STATE OF NORTH CAROLINA
DEPARTMENT OF TRANSPORTATION

Subject: Application for Modification to Section 404 and Section 401 permits and Neuse Buffer Certificate for the Northern Wake Expressway (I-540) from US 1 to US 64 in Wake County, Division 5. State Project No. 8.2401701, Federal Aid Project No. F-123-1(1), TIP No. R-2000 F&G; \$475.00 Debit Work Order 8.2401701, WBS Element No. 34365.1.1. NCDENR-DWQ Water Quality Certification Project No. 030114 and USACE Action ID 199920387.

The purpose of this submittal is to request a modification to the Section 404 permit and Section 401 Water Quality Certification and Neuse Buffer Certificate, specifically for Sections F&G. The modification for the permit is for several changes to jurisdictional and buffer impacts through construction modifications and to state discrepancies found by NCDOT personnel between the permit drawings and the construction plan sheets.

SHEET 7 OF 10

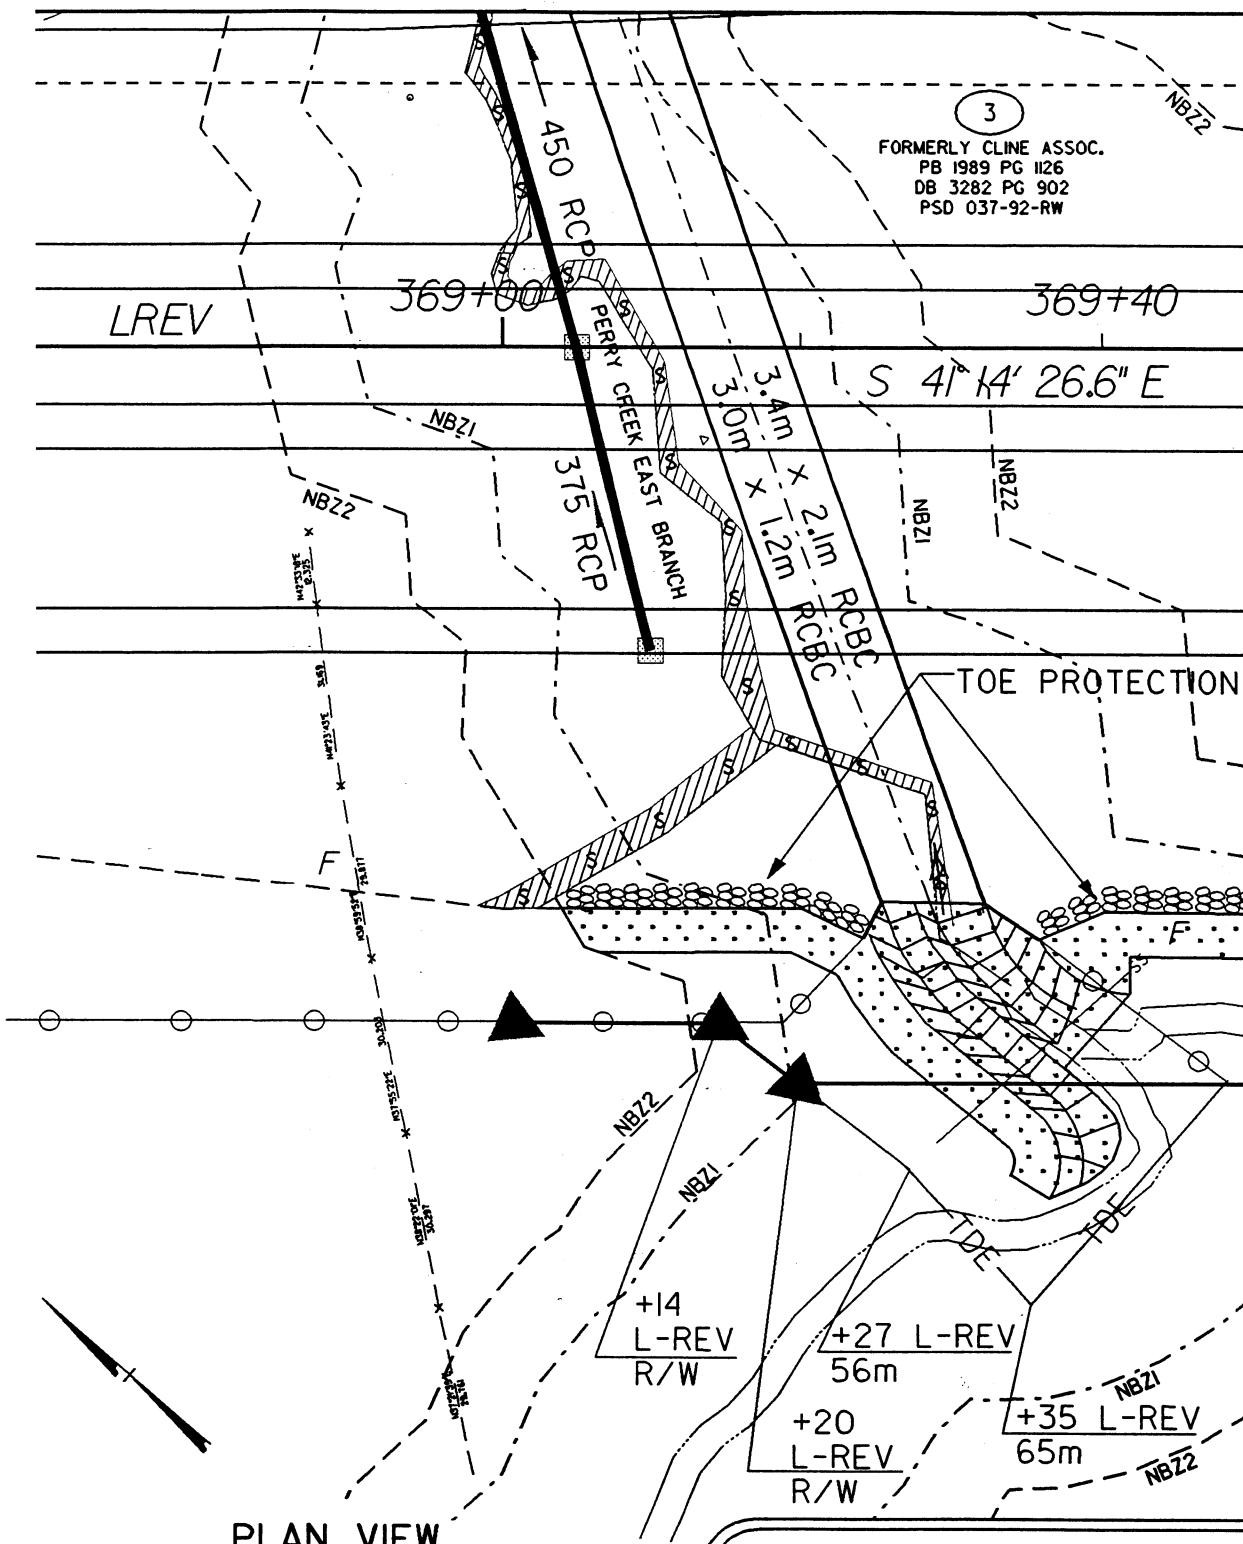
Permit Drawing 7/Plan Sheet 8/Site 2

The permit drawing was revised to show buffer impacts associated with construction of the 0.6m base tail ditch. Additional buffer impacts are 96 square feet (sq ft) of excavation in each Zone 1 and Zone 2, 1611 sq ft mechanized clearing in Zone 1 and 1045 sq ft mechanized clearing in Zone 2.

SHEET 9 OF 90

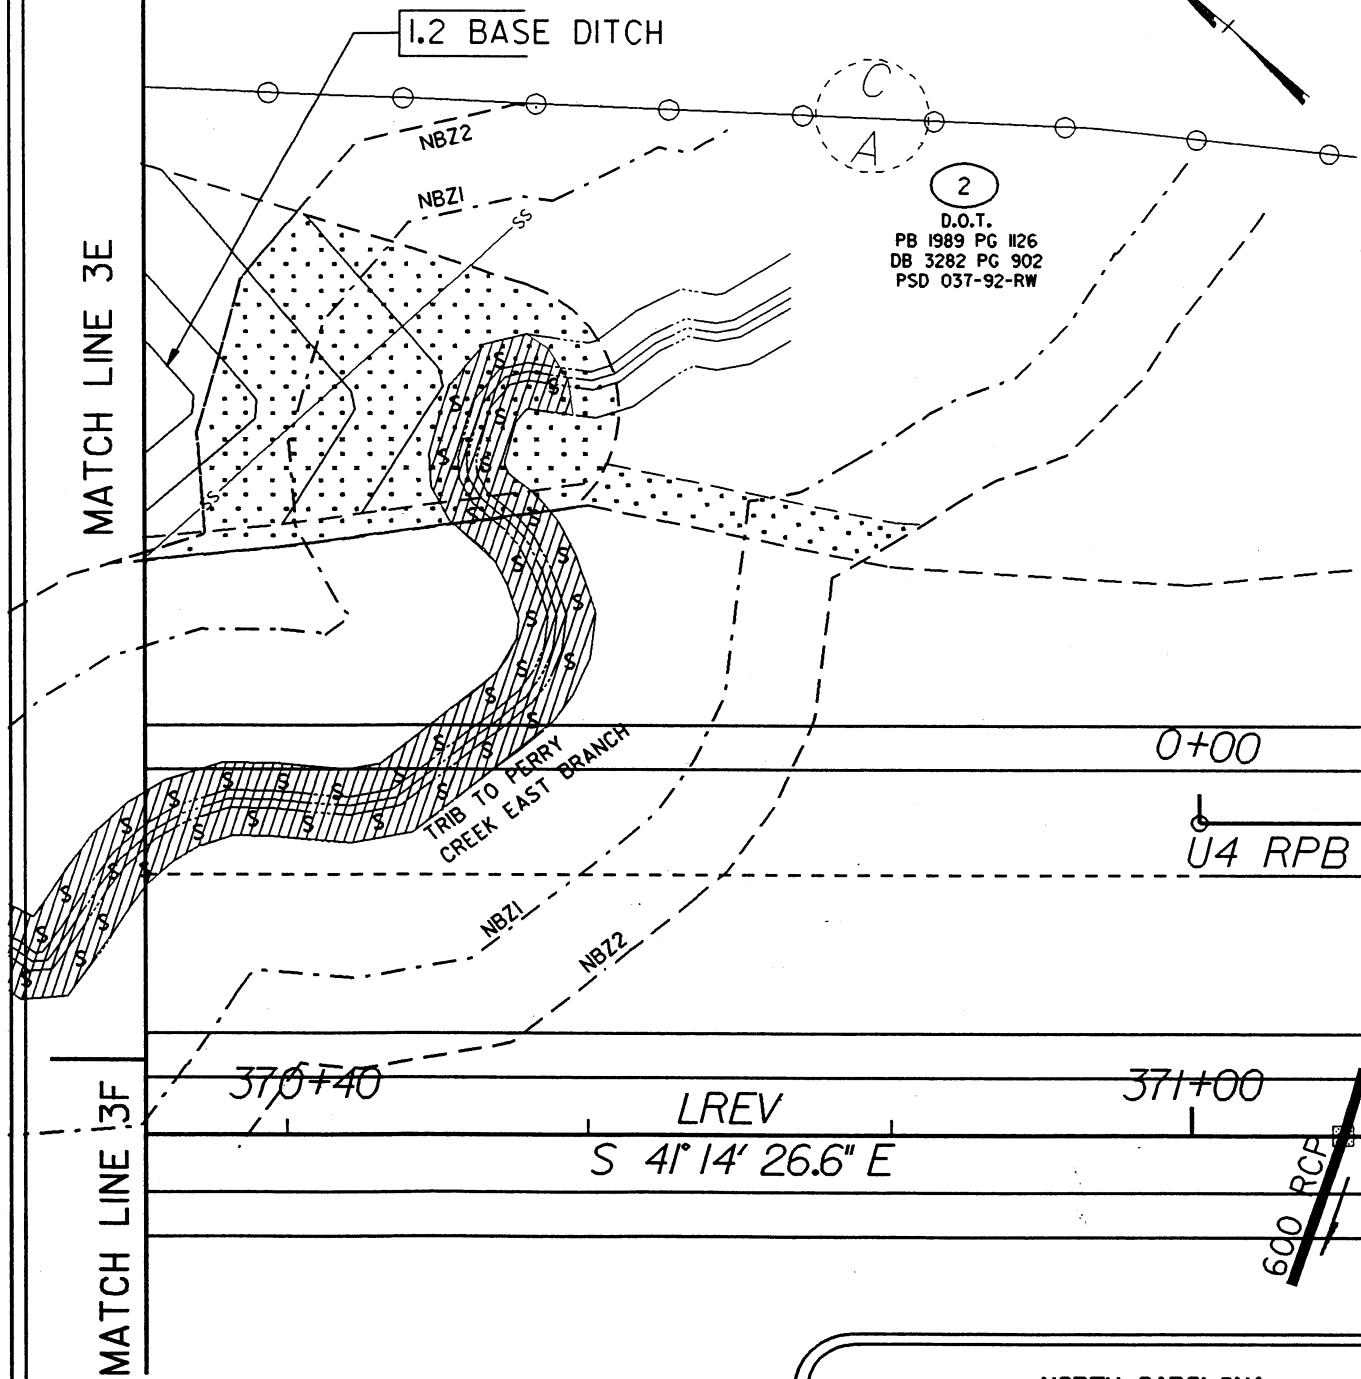
Permit Drawing 9/Plan Sheet 10/Site 3

The permit drawing was revised to reflect the toe protection at Station 369+10 to be in agreement with the construction plans. There are no additional impacts at this site.

SHEET 14 OF 90

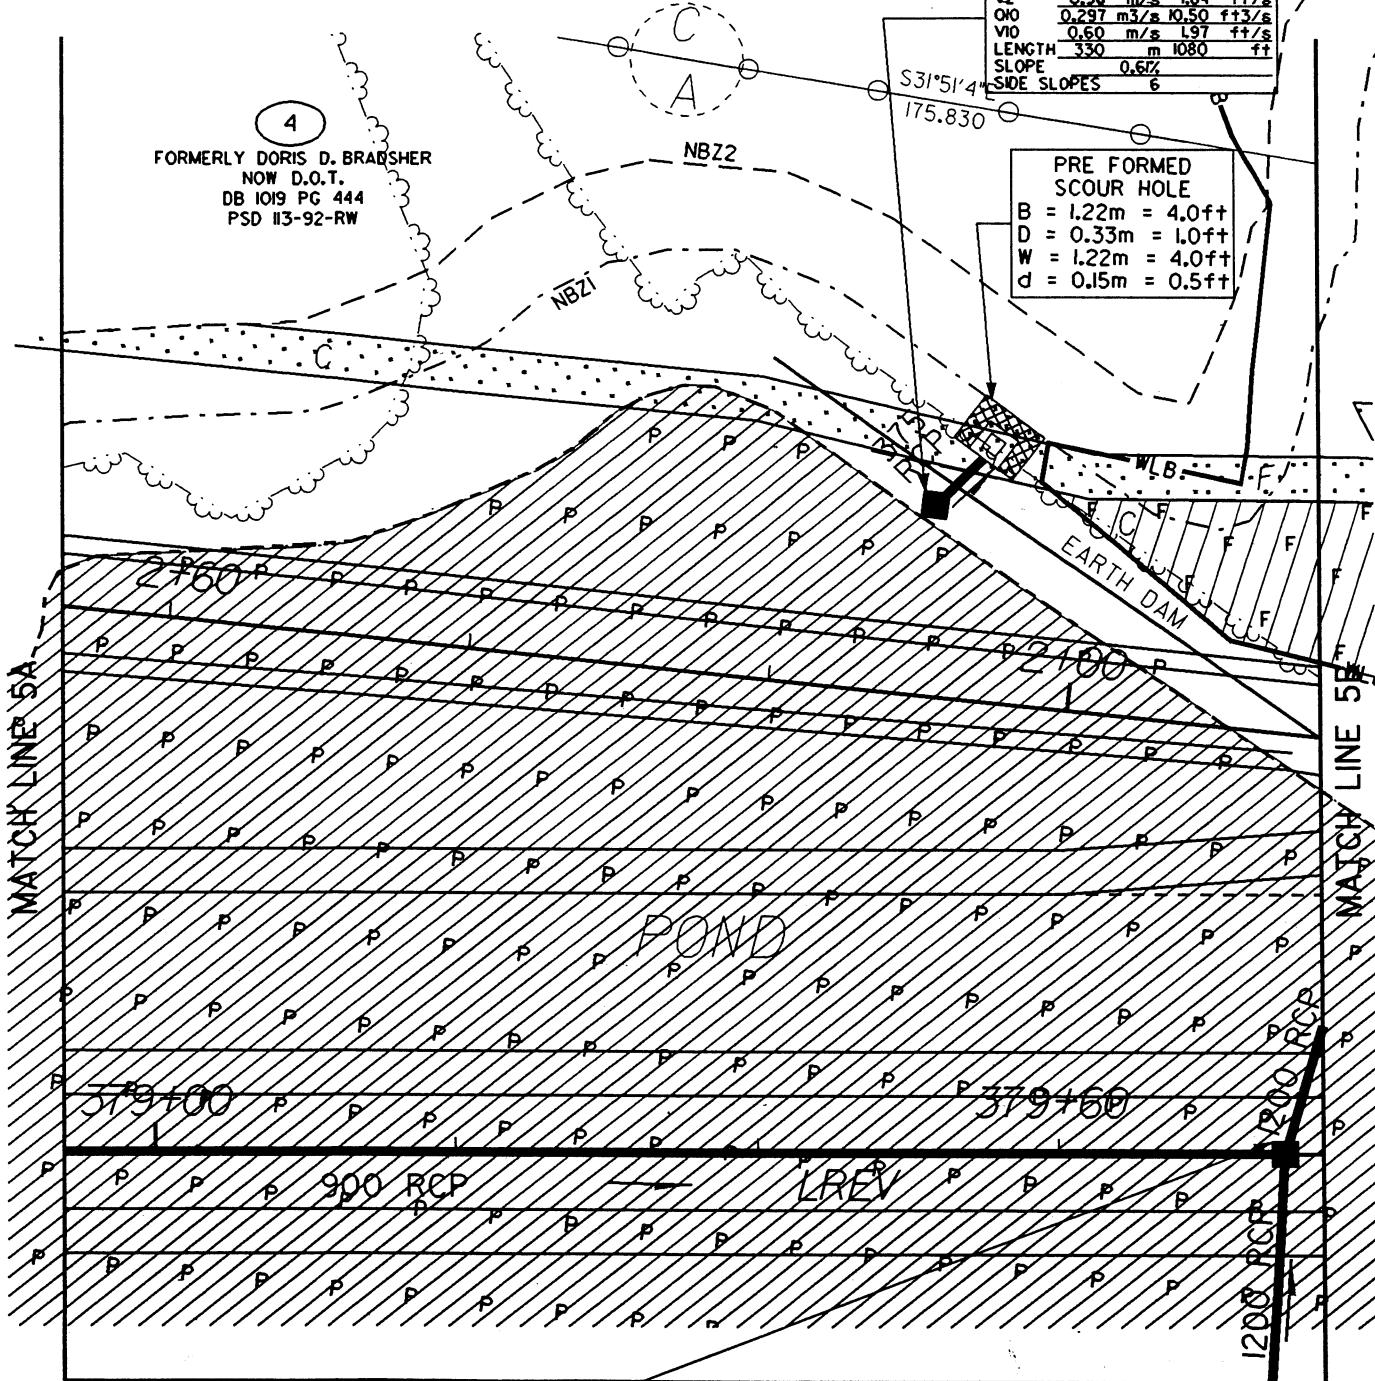
Permit Drawing 14/Plan Sheet 10/Site 3

The permit drawing was revised to depict the additional buffer impacts of mechanized clearing along the toe of fill from Station 370+60 to 370+80. The additional buffer impacts are 348 sq ft of mechanized clearing in Zone 1 and 305 sq ft in Zone 2.

Sheet 23 of 90

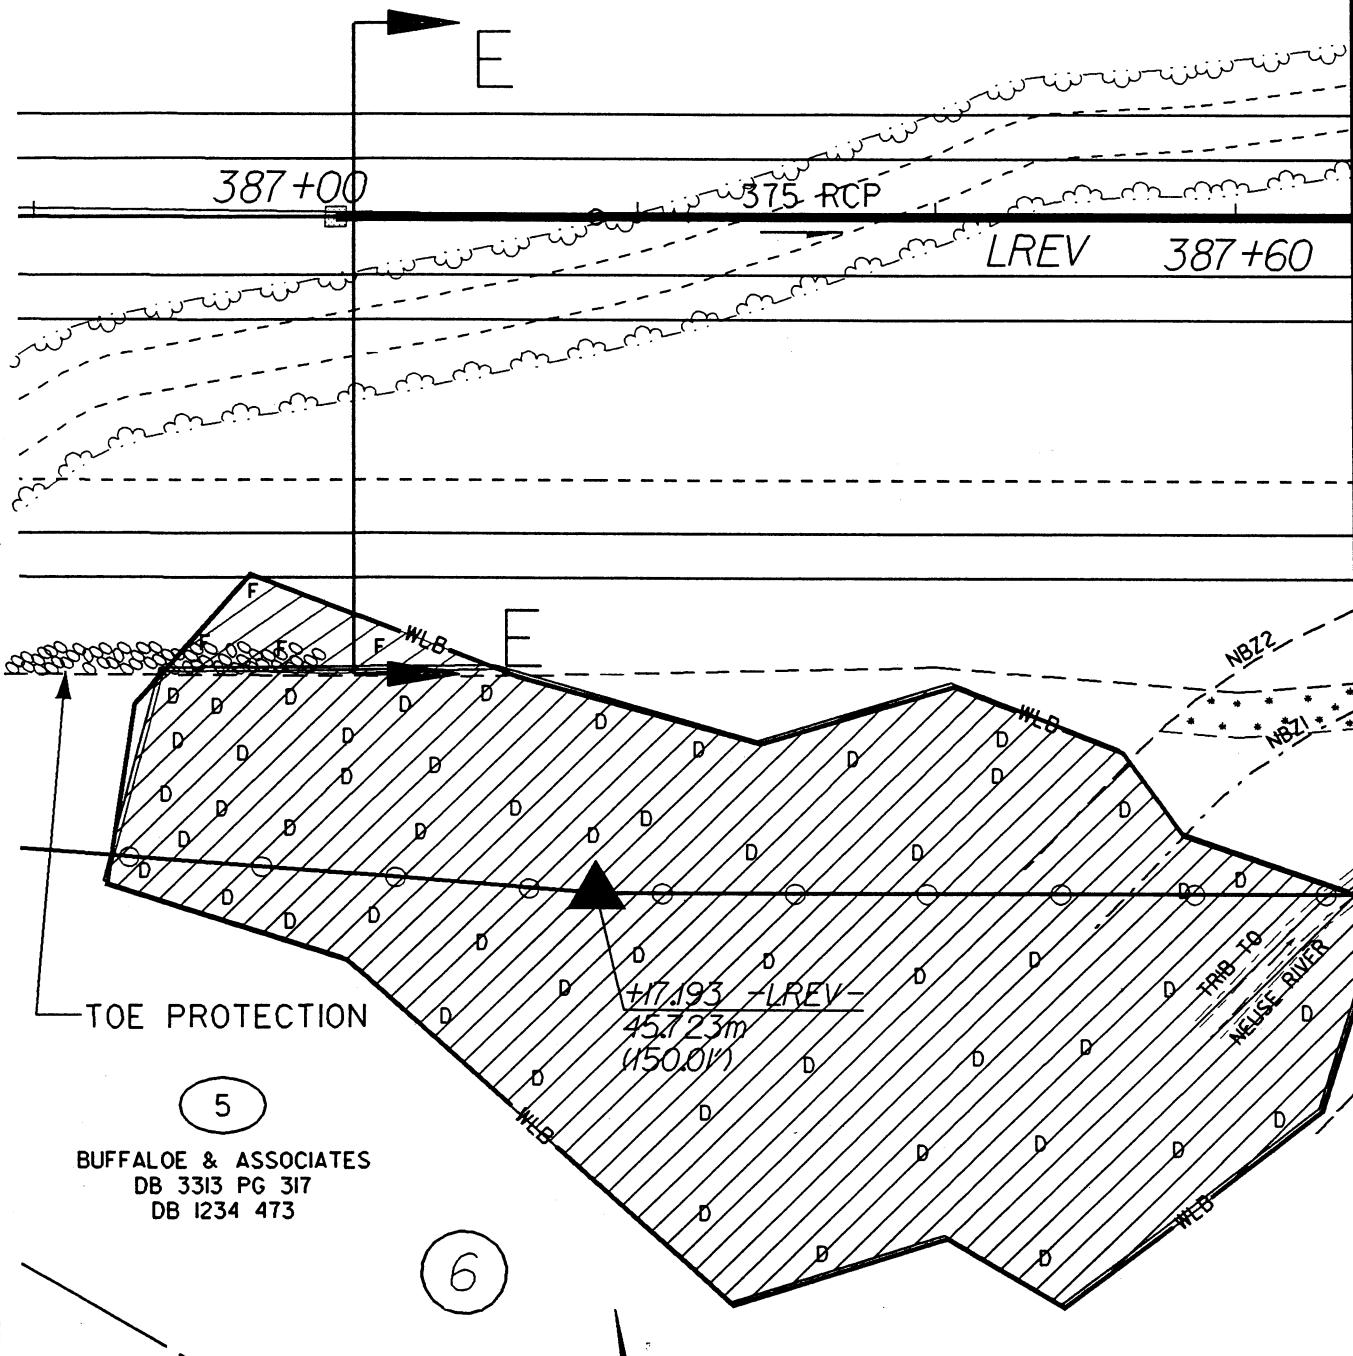
Permit Drawing 23/Plan Sheet 12/Site 5

Permit drawing will be revised to reflect the proposed berm drainage outlet (BDO) as reflected on the plans. No jurisdictional impacts will be result from this addition.

SHEET 29 OF 40

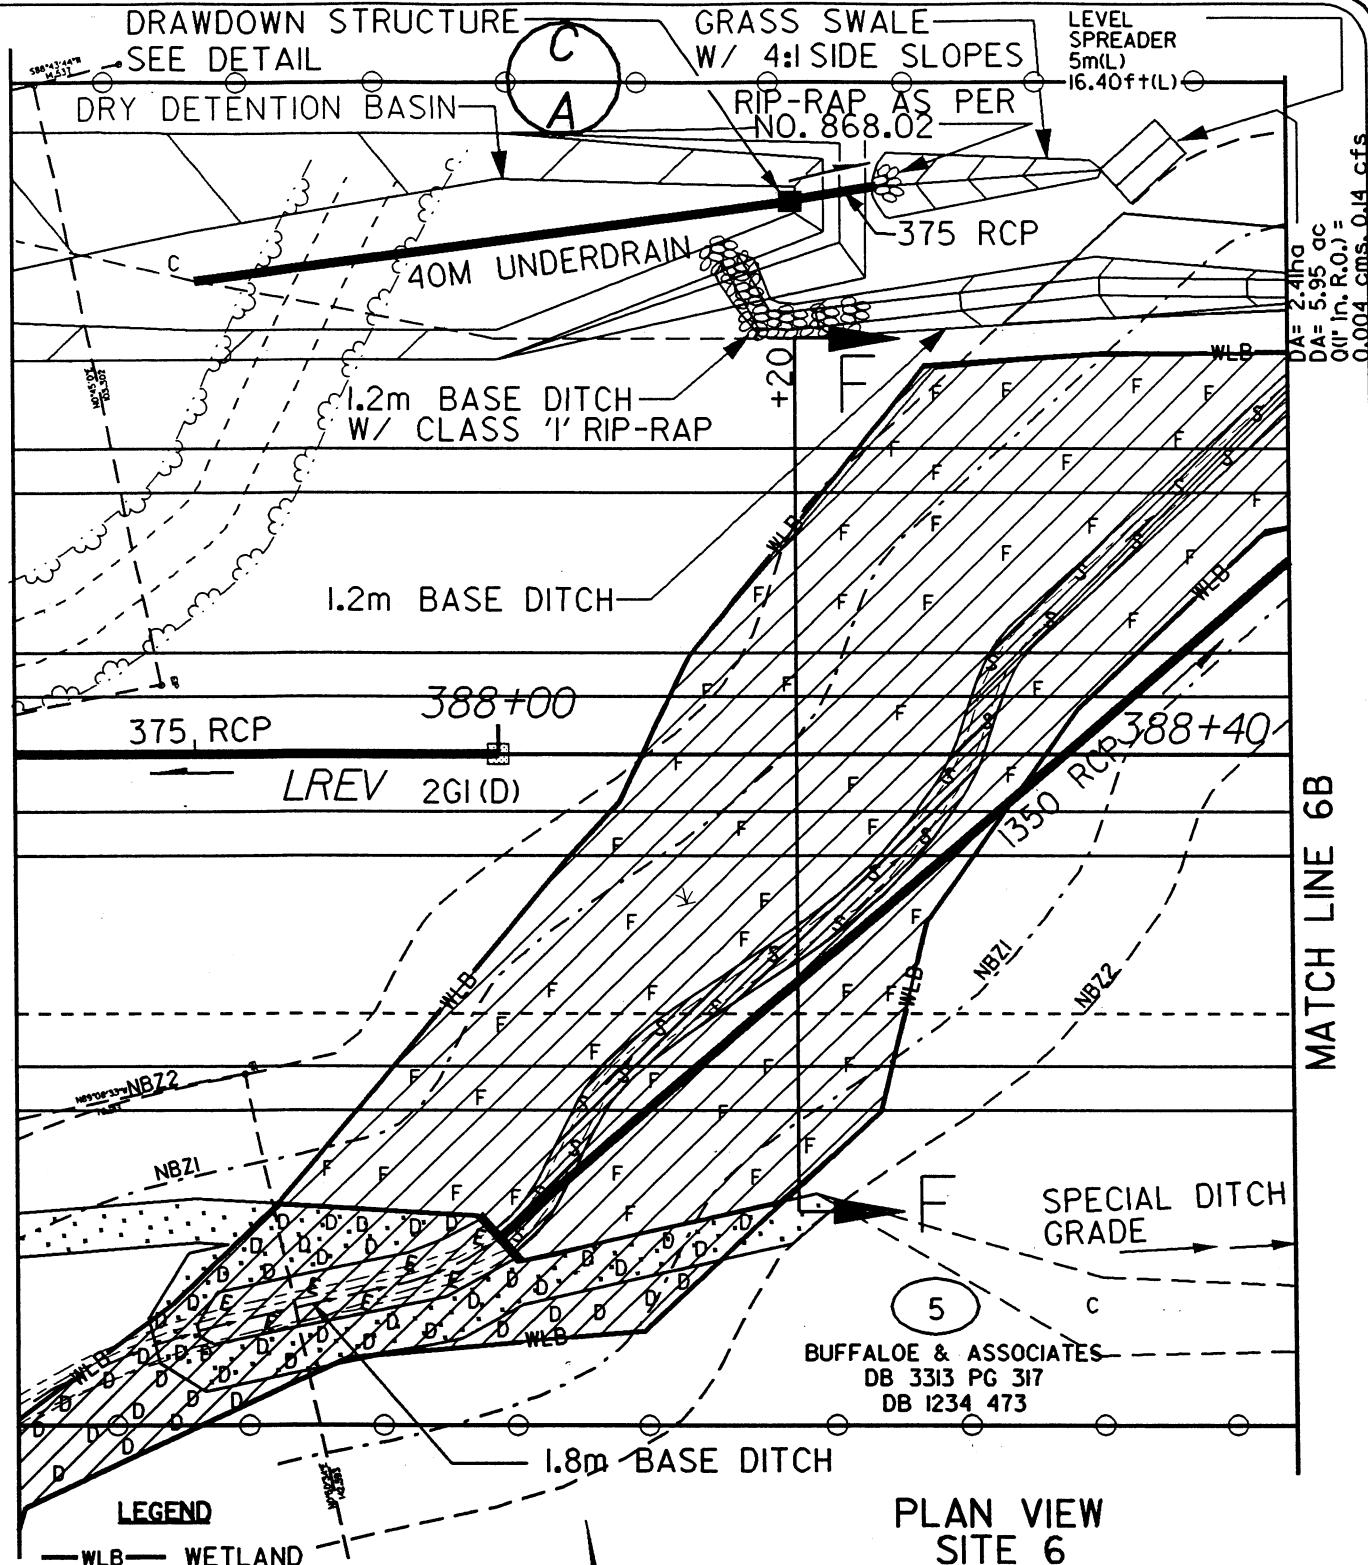
Permit Drawing 29/Plan Sheet 14/Site 6

Original permit drawing depicted excavation in a wetland outside the project construction limits. This impact is more correctly described as a drained wetland instead of excavated. The wetland is considered a total take. The permit drawing is revised as such. There are no changes in jurisdictional impacts.

The permit drawing was also revised to depict the required mechanized clearing in the buffers along the toe of fill from Station 387+60 to 387+80. The additional impacts are 87 sq ft of mechanized clearing in Zone 1 and 261 sq ft in Zone 2.
